In the Matter of: Entergy Nuclear Operations, Inc.
(Indian Point Nuclear Generating Units 2 and 3)

**UNITED STATES
NUCLEAR REGULATORY COMMISSION
ATOMIC SAFETY AND LICENSING BOARD**

**STATE OF NEW YORK AND RIVERKEEPER, INC.
SUPPLEMENTAL REPLY STATEMENT OF POSITION
CONSOLIDATED CONTENTION NYS-26B/RK-TC-1B**

Figure 1: Comparison of Limit Line (LL) and Best Estimate (BE) predictions, with embrittlement (BE_e) and without embrittlement (BE_{ne}) (Exh. NYS000566).

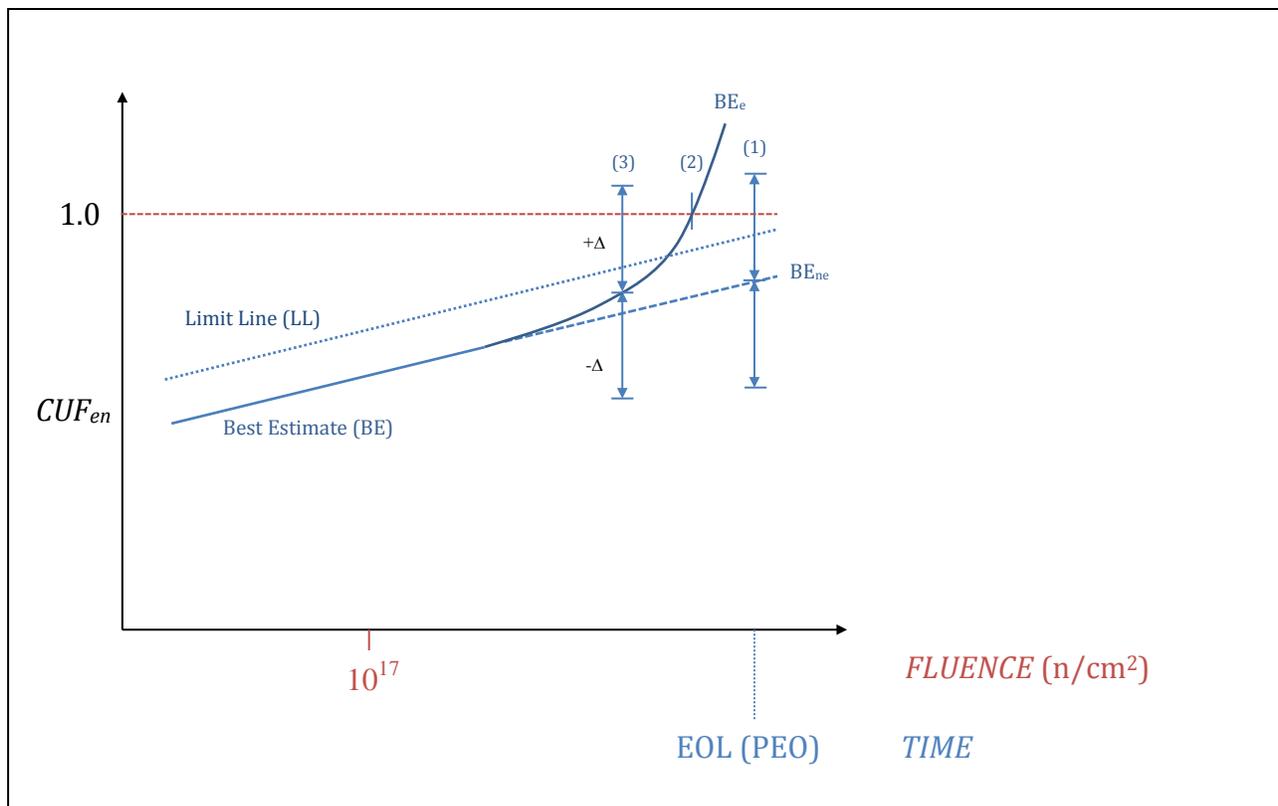
Dr. Lahey prepared a chart to illustrate how increased fatigue in RVI components impacts the possibility of fatigue failure, as well as the effects of fatigue on embrittled and non-embrittled components. *See* Comparison of Limit Line (LL) and Best Estimate (BE), Figure 1, *infra* (Exh. NYS000566). Dr. Lahey describes this figure in detail in his Reply Testimony, at 8-17. Figure 1 shows time and fluence on the x-axis, and CUF_{en} on the y-axis. The graph plots two possible

CUF_{en} calculations for a hypothetical component: (1) a “limit line” showing the supposed bounding and conservative EAF calculation [REDACTED]; and (2) a “best estimate” line showing a possible EAF calculation that would attempt to accurately predict fatigue life for the component. Additionally, the “best estimate” line depicts an EAF calculation that does not consider embrittlement (BE_{ne}) as well as an EAF calculation that does consider embrittlement (BE_e). Lastly, the best estimate line depicts a delta range (Δ) to represent the uncertainty in the EAF calculation.

Although the “limit line” is above the “best estimate” line (i.e., predicts a higher CUF_{en} value) through most of the component’s life, the uncertainty bar shows that the actual CUF_{en}

value may exceed the limit line – that is, the uncertainty may be greater than the conservatism in the calculation. The chart also depicts three locations where cracking and component failure may occur. At location 1, the best estimate line that does not account for embrittlement may exceed 1.0 towards the end of the plant’s period of extended operation (PEO), due to uncertainty in the CUF_{en} output. This is true even though the supposedly conservative limit line is still below 1.0. At location 2, the best estimate line that considers embrittlement exceeds 1.0 late in the component’s life, but well before the end of the PEO. This reflects the fact that embrittlement may reduce the number of fatigue cycles to failure, especially as the component is subjected to fluence greater than 10^{17} n/cm². Finally, location 3 shows that when embrittlement and uncertainty are factored into the best estimate line, the component may fail long before the end of the PEO. Notably, [REDACTED] it is impossible to determine whether uncertainty is greater than conservatism, or when the combined effects of embrittlement and uncertainty may cause a component’s CUF_{en} to exceed 1.0. Lahey Reply Testimony, at 16-17.

Figure 2. Emergency Core Cooling Systems. Source: NRC, Reactor Concepts Manual –PWR Systems Manual, at 4-25 (Exh NYS000563).

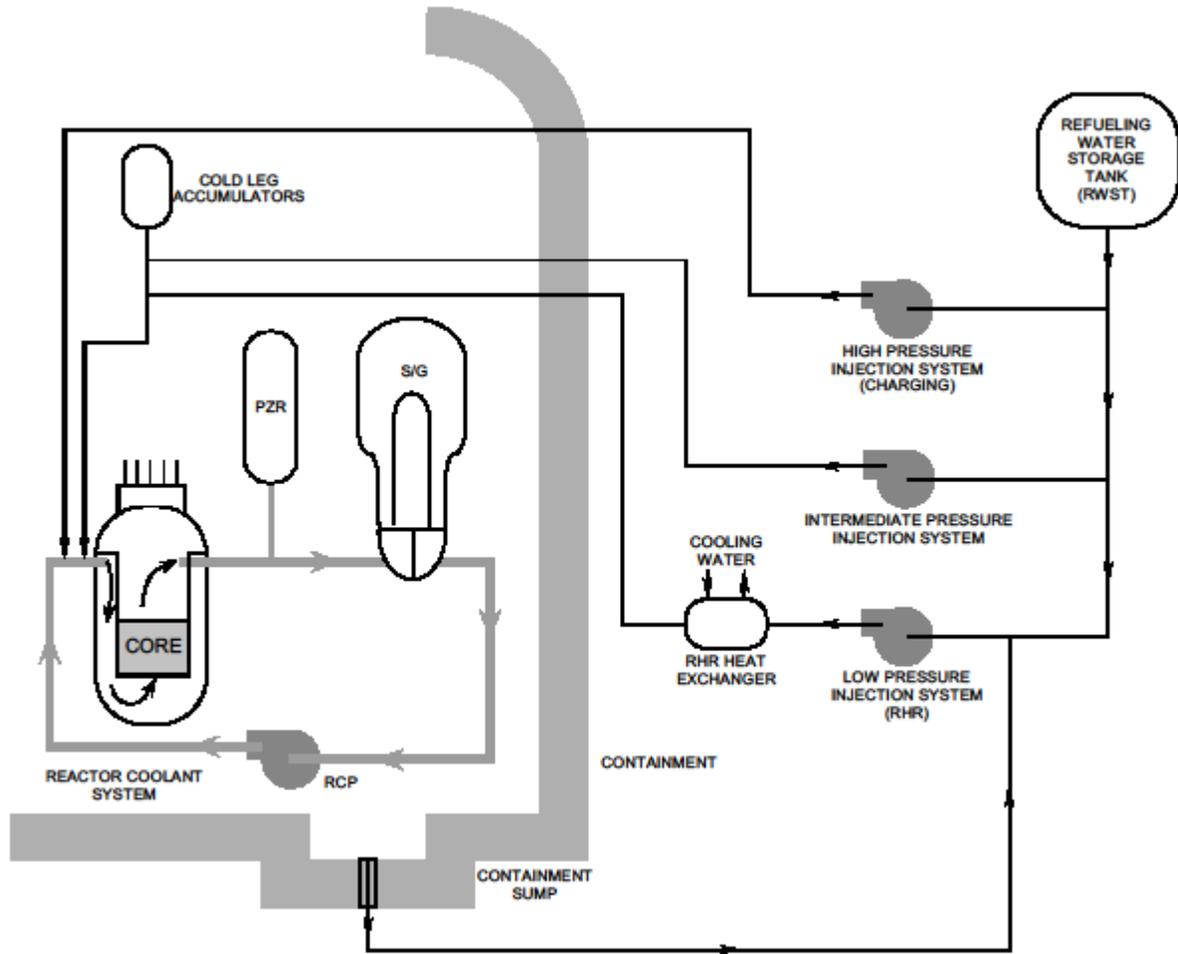
[REDACTED] the accumulators uses the same nozzle as

the residual heat removal (RHR) system and the low pressure coolant injection (LPCI) and

intermediate pressure coolant injection (IPCI) safety systems. See NRC, Reactor Concepts

Manual –PWR Systems Manual, at 4-25 (Exh NYS000563); Figure 2, *infra*. If the nozzle were

to fail as a result of unaccounted for uncertainty in the EAF calculation or an unexpected seismic

event or shock load, the result could be a LOCA event in which the accumulator, LPCI and IPCI

systems would not be able to inject water into the cold leg and then into the core, resulting in a core meltdown. Lahey Reply PFT, at 29-30.
